KEY PLAN
 Proposed modified composite structure plan of Sector G-7 & G-8, Narela Subcity

Part Layout Plan of recreational pocket in modified Composite Structure Plan of Sector G-7 & G-8, Narela - to provide 1500 sqm. plot (30m X 50m) for the construction of 1.5 MLD capacity sewage treatment plant (STP)

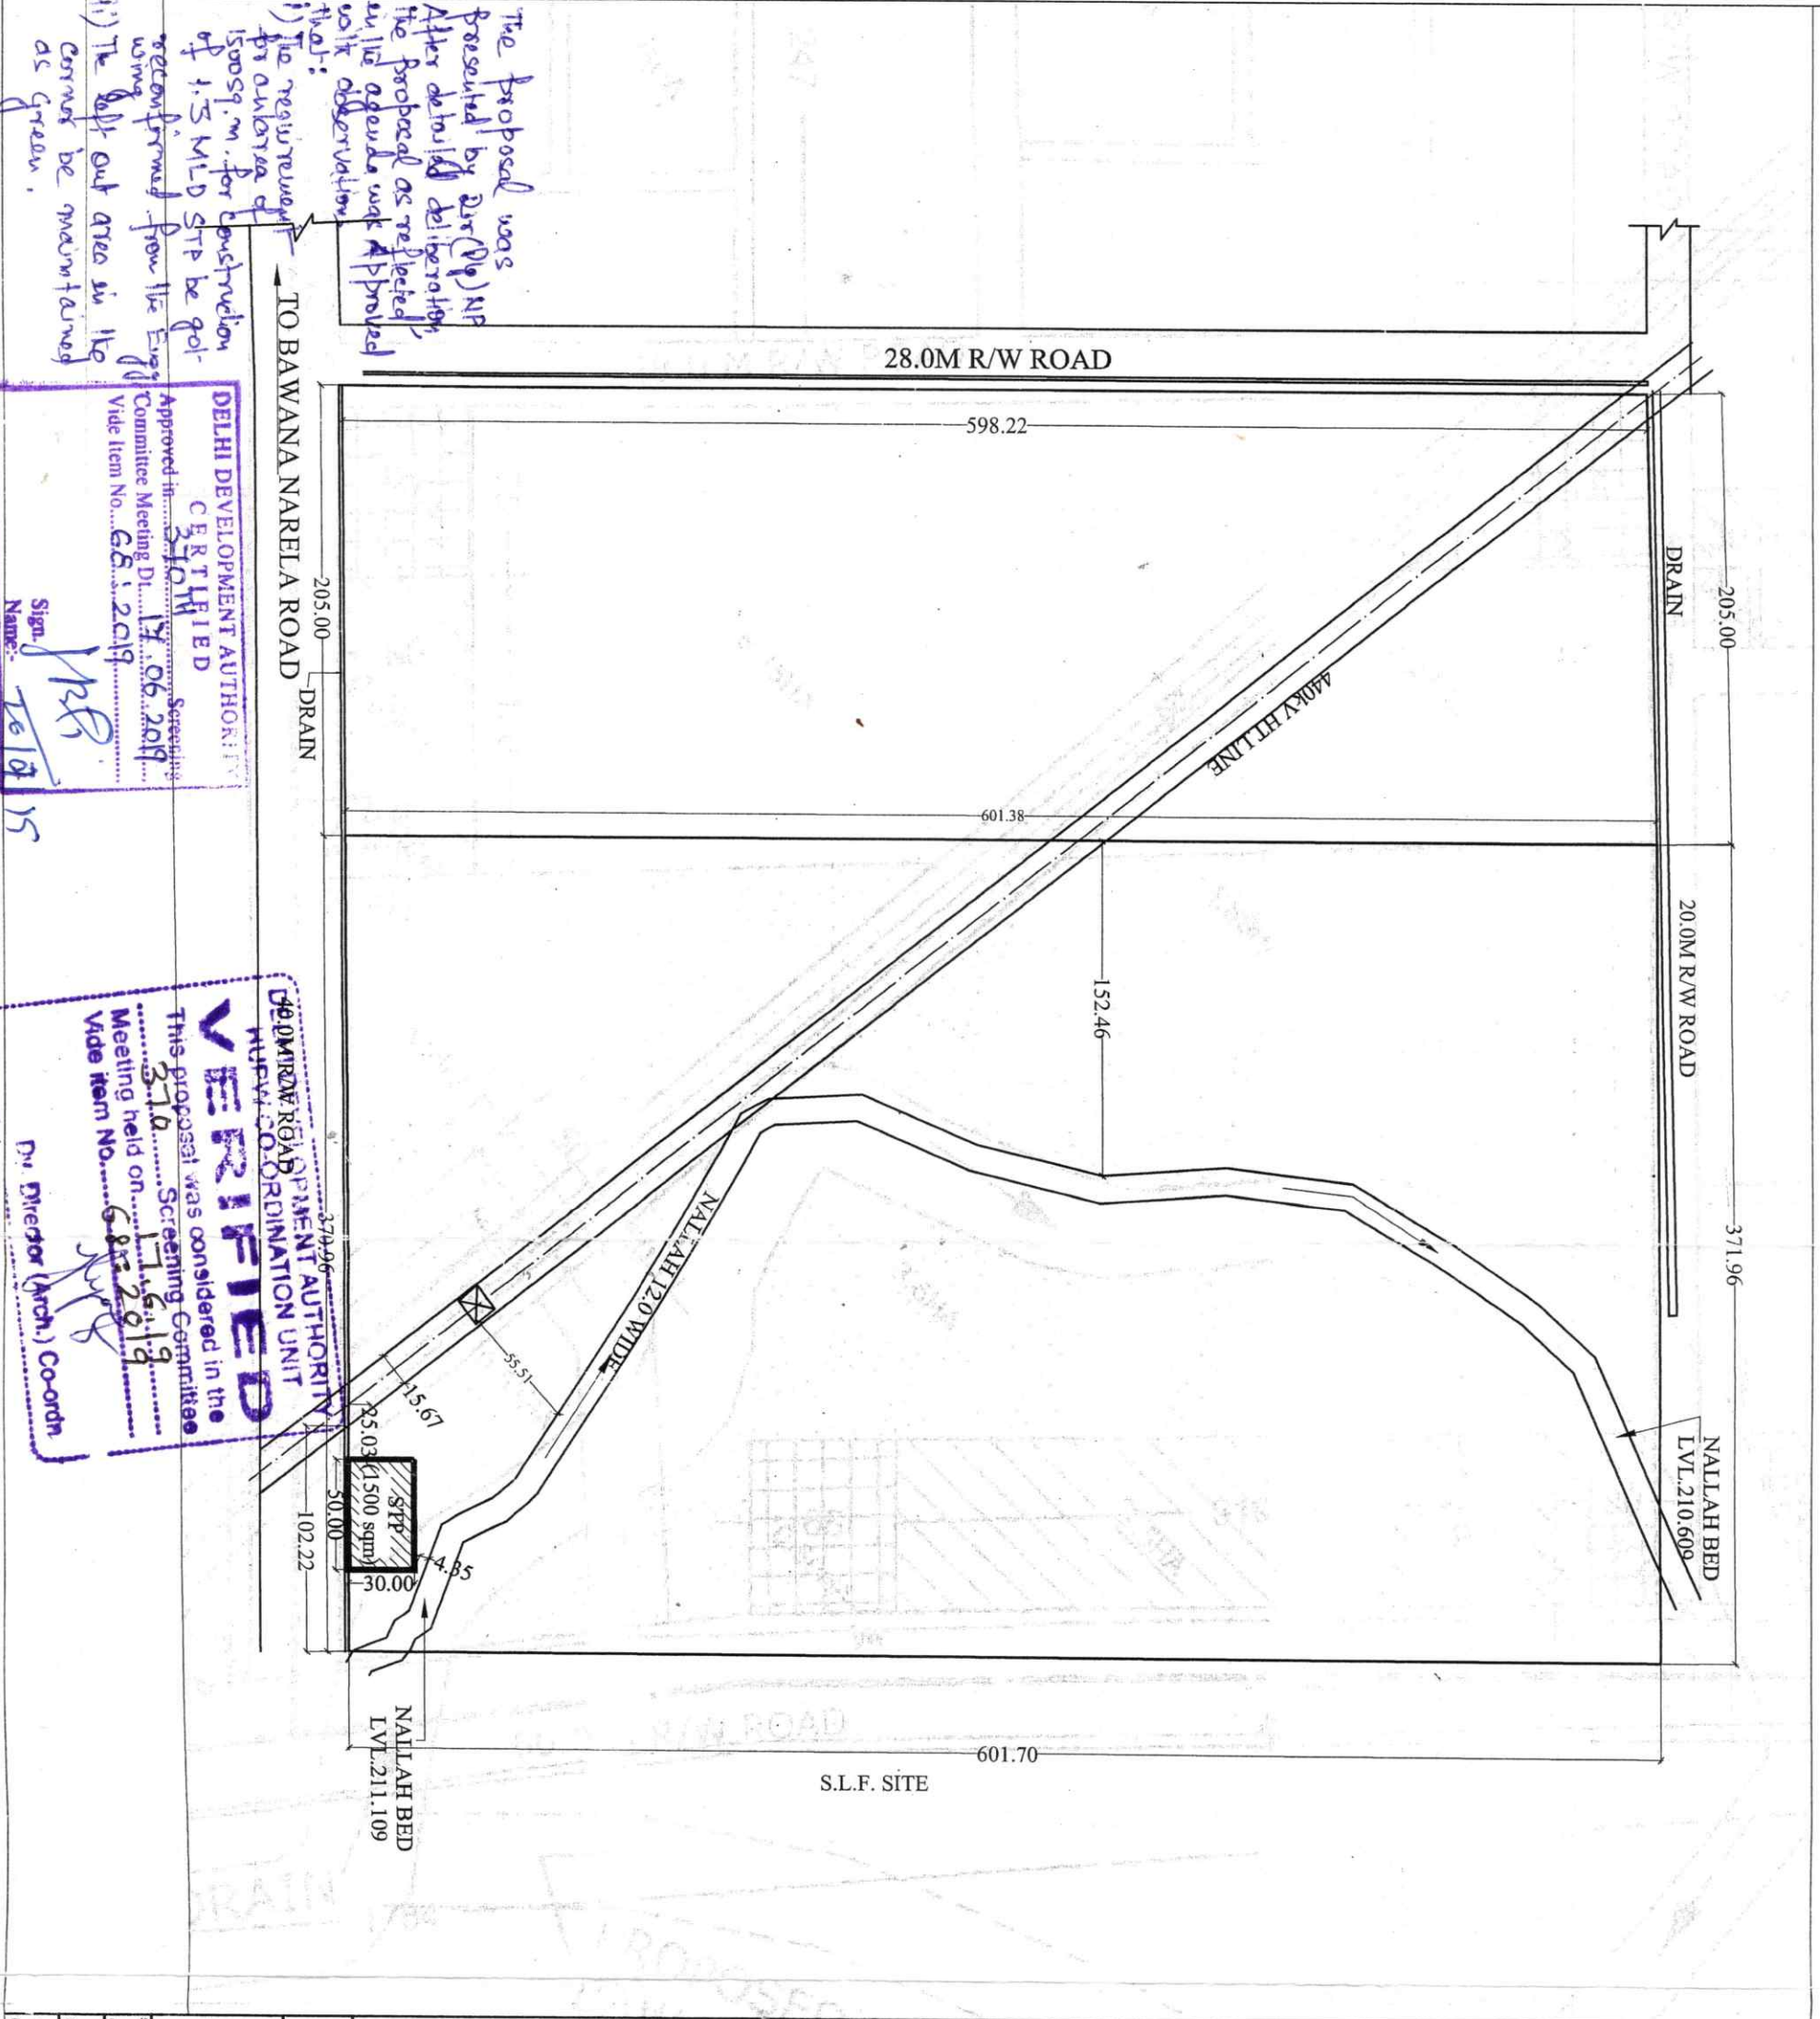
The proposal was presented by Mr. (P) NP After detailed deliberation the proposal as reflected in the agenda was approved with observation that:-
 1) The requirement for diversion of 1500sq.m. for construction of 1.5 MLD STP be got reconfirmed from the Energy Commission Meeting D. 17.06.2019 Vide Item No. 68.1.2019
 2) The left out area in the corner be maintained as green.
